City of Lone Tree Planning Commission Agenda Tuesday, May 24, 2016

TO: City of Lone Tree Planning Commission

Approval of a Site Improvement Plan (SIP) to construct a single-story, 9,930 square-foot, medical office building on 1.05 acres in RidgeGate. In conjunction with this SIP, there are two variances proposed: one is a variance to the City parking standards to allow parking in excess of the City's maximum standards; the other is a variance to the RidgeGate Office District Sub-Area Plan regarding waiver of a build-to standard that would allow the building to be set back 10 feet from the street.

RIDGEGATE SECTION 15 FILING NO 12, FIRST AMENDMENT, LOT 3B

SITE PLAN

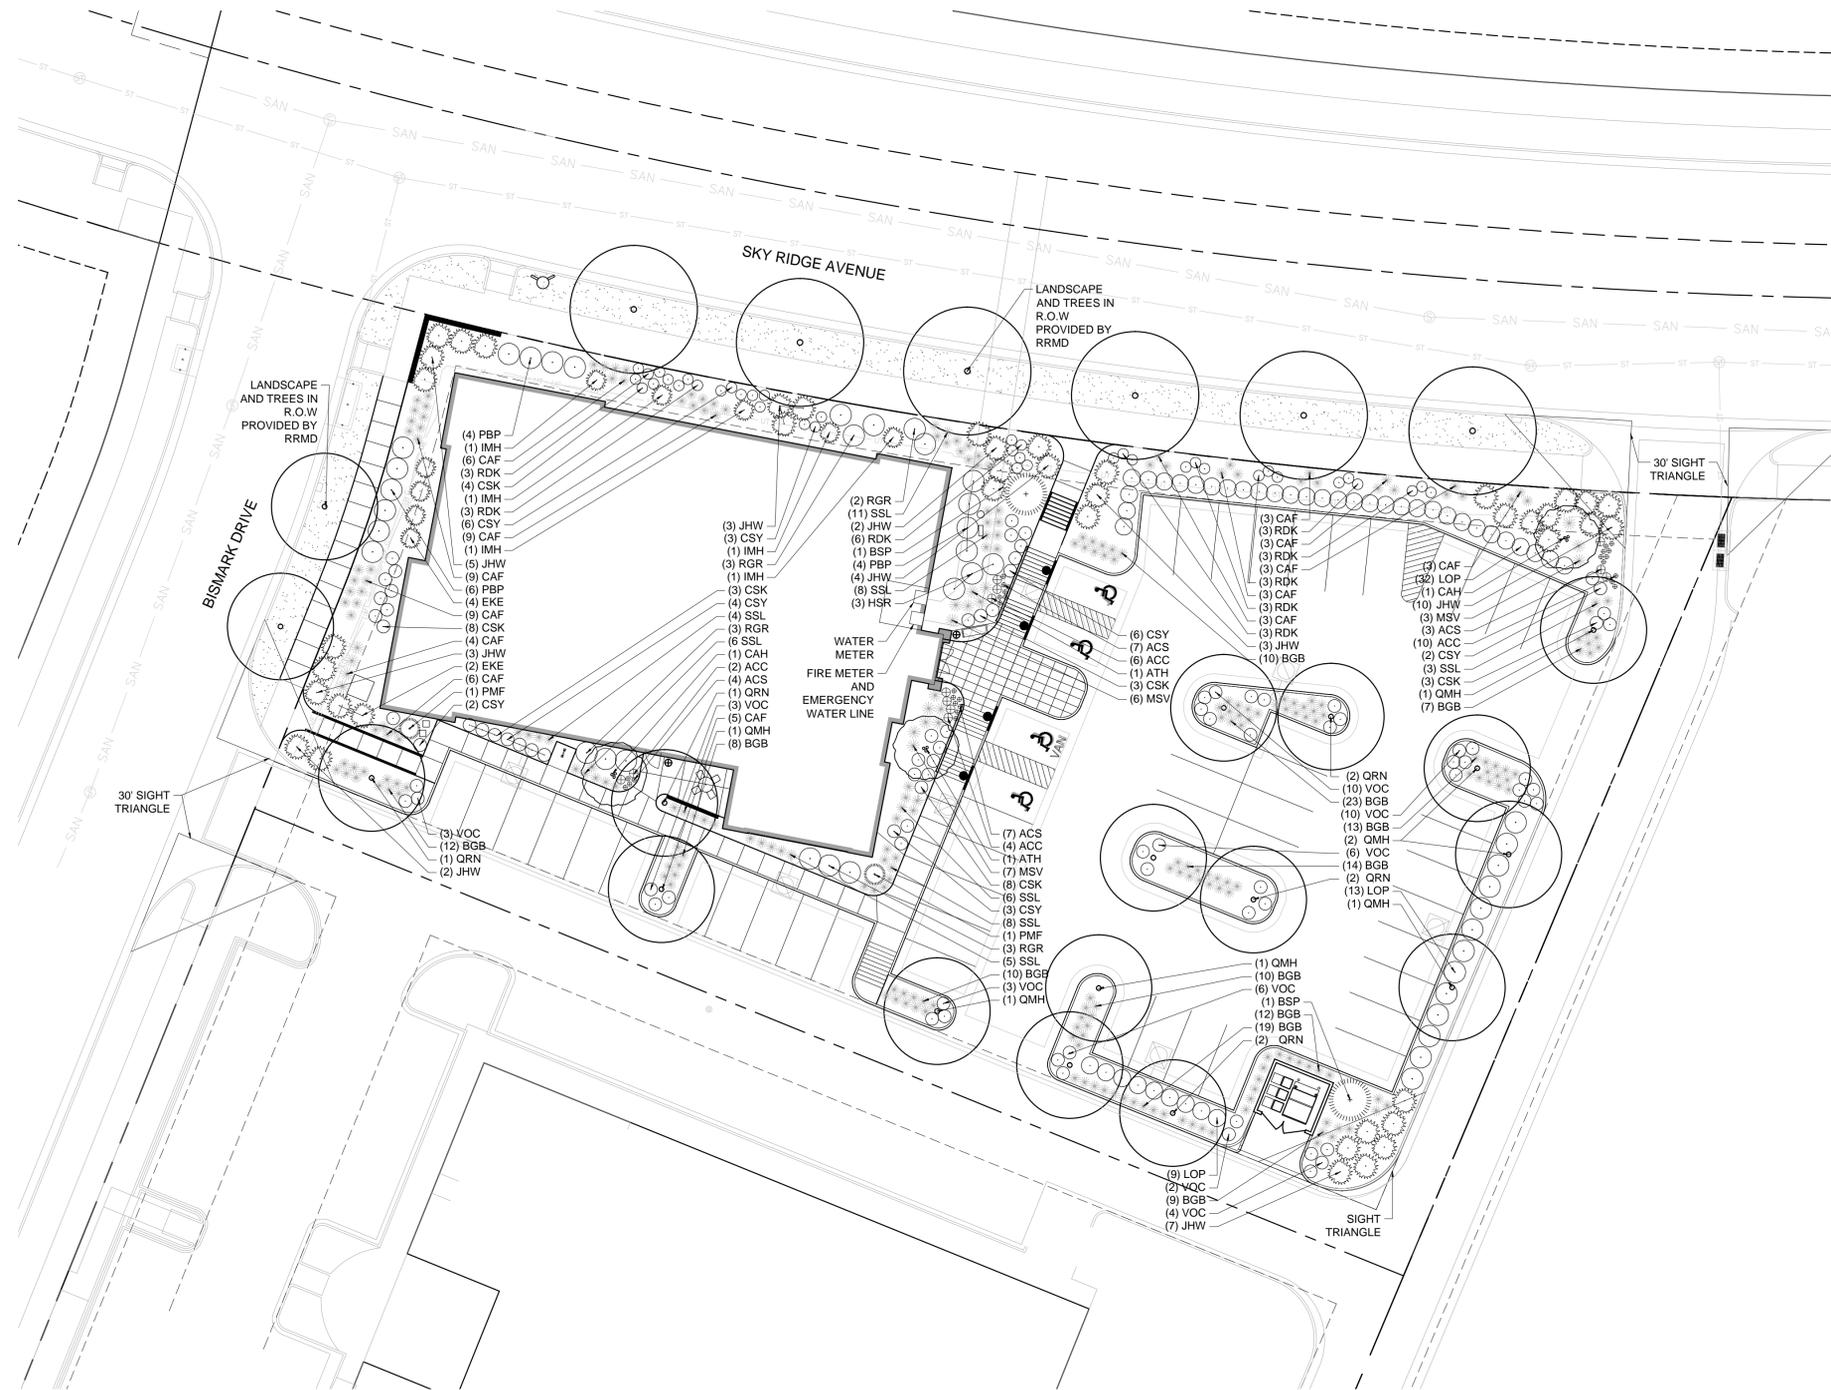
- Provide photometric plan at next submittal.
- Designate location for snow storage on plans.
- Annotate on the plans what landscaping will be the responsibility of RRMD.
- Coordinate with RRMD.
- Consider opportunities to increase the south side experience, e.g. increase patio size.

- Consider opportunities to add small ornamental trees between the sidewalk and the building.
- Consider adding a retaining wall at the northwest corner of the site and create bench seating near the sidewalk where people can sit. This wall could also be a signage element.

- Develop grading plans and provide at next submittal.
- Consider flipping the building on the site (sketch included).
- Study the scale of lighting in medians and analyze the existing lighting from the daycare to determine actual lighting needs.

- Consider adding a privet along the Sky Ridge edge to screen parking.
- Locate the Xcel transformer and screen.
- Provide monument sign details at next submittal.

- Consider adding a bicycle rack.
- Address recycling program and if provided in trash enclosure.
- Provide trash enclosure details with next submittal.
- Consider using masonry on the southwest corner element rather than stucco.

- The building footprint was flipped and pushed north against the utility easement. This allowed for patio space on the south side of the building to be added.

- Site lighting was placed in planting areas and off site. Security lighting was added to building entrances.
- A bike rack was added.
- The monument sign was deleted.

- Added a seat wall to help with grade at the northwest corner of the site.
- The trash enclosure was moved off site to the southeast corner. Enclosure will be constructed of CMU material.

LANDSCAPE PLAN

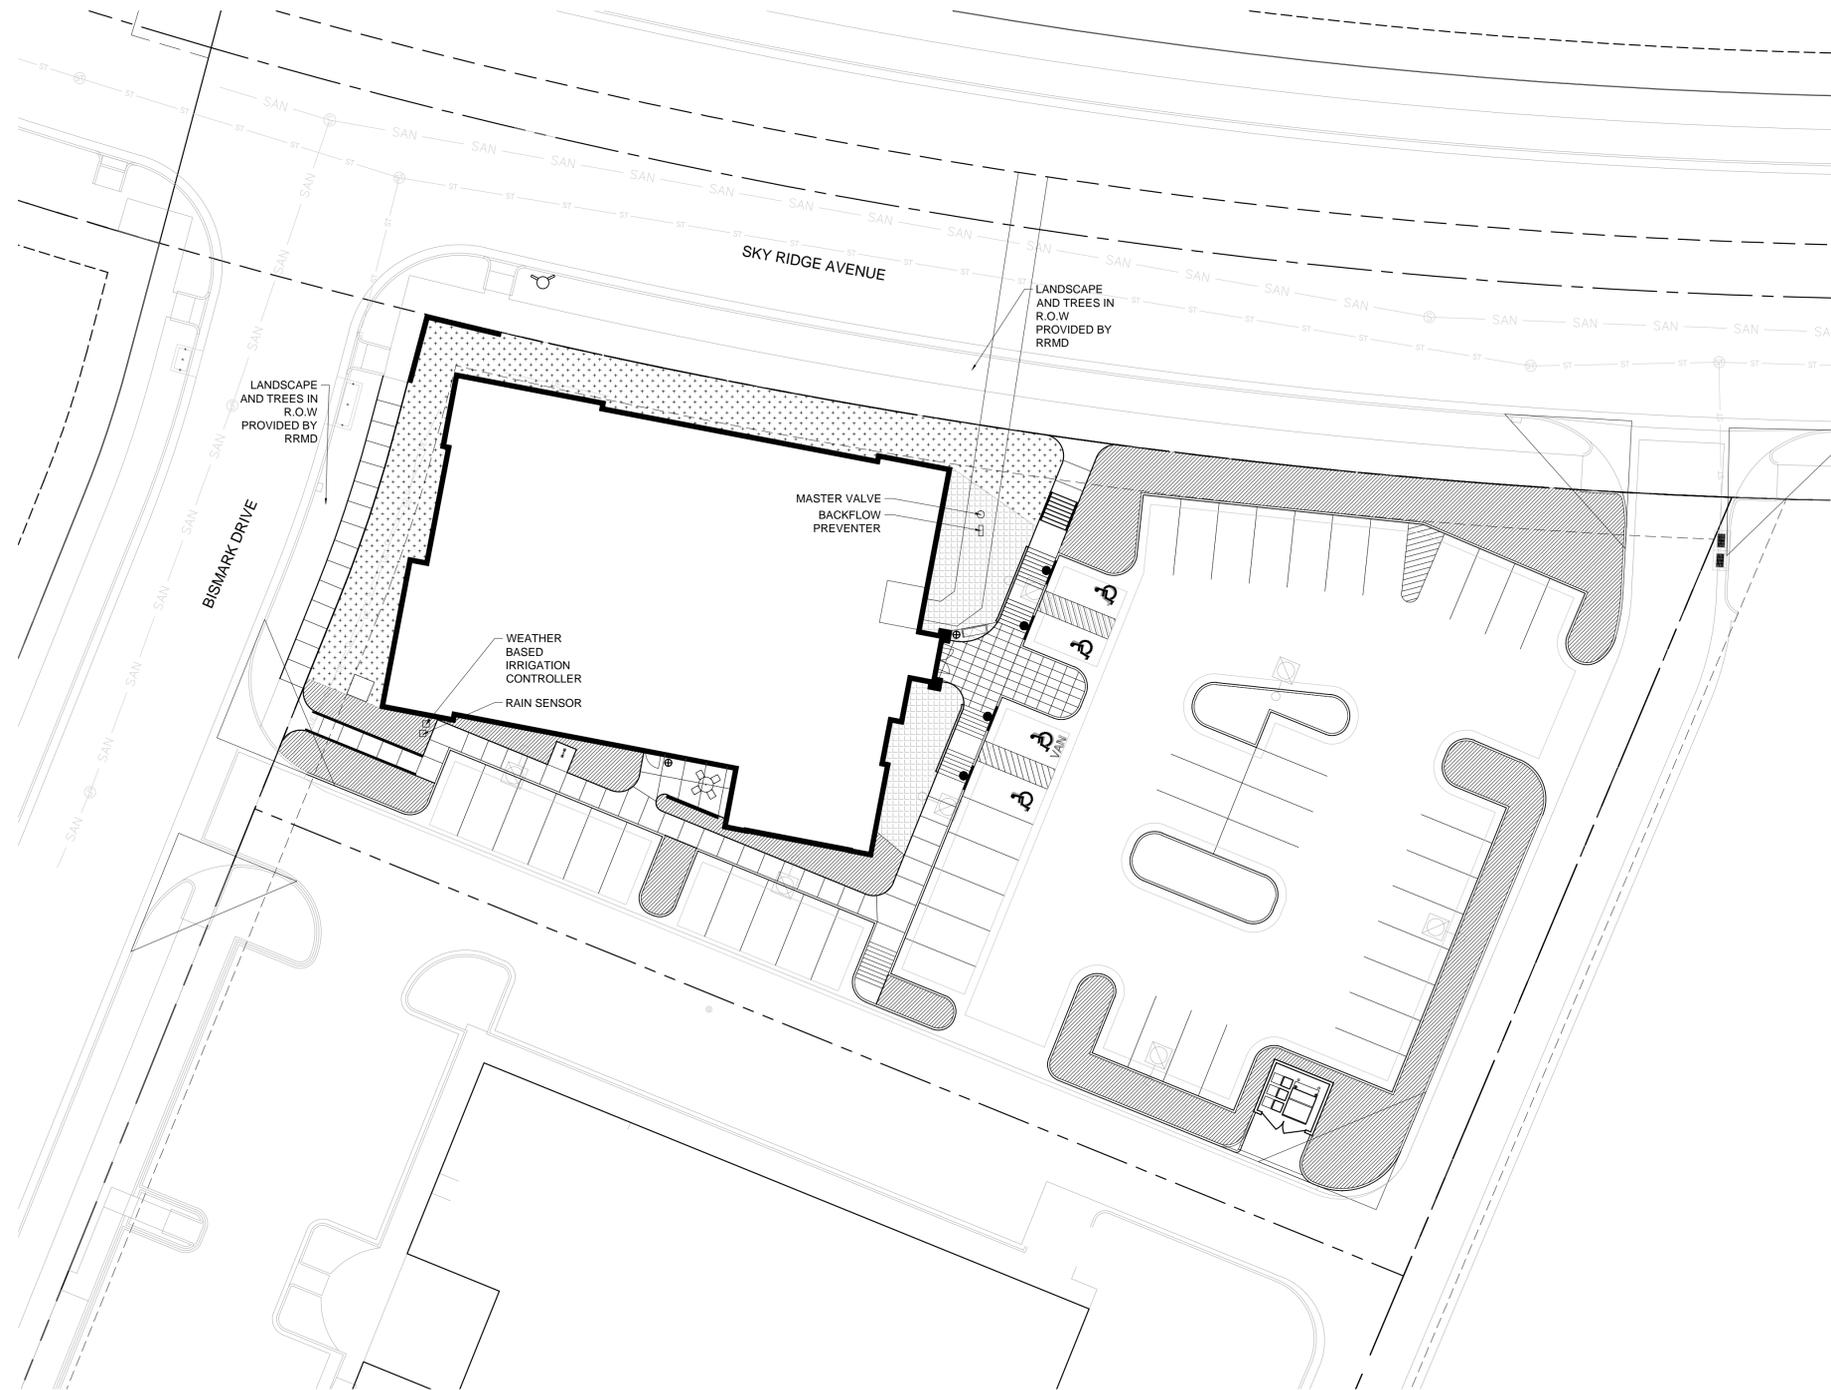
- Specify the trees that will be planted to confirm they will not have low branching and interfere with pedestrian movement.
- Revisit grading plan and drainage flow around the L island in the parking lot.

- Consider using the same brand of site furniture.
- Screen the transformer with more substantial shrubs or evergreens.
- Consider adding an evergreen tree at the southeast corner where the trash enclosure is currently placed. Add an outlet for seasonal light.
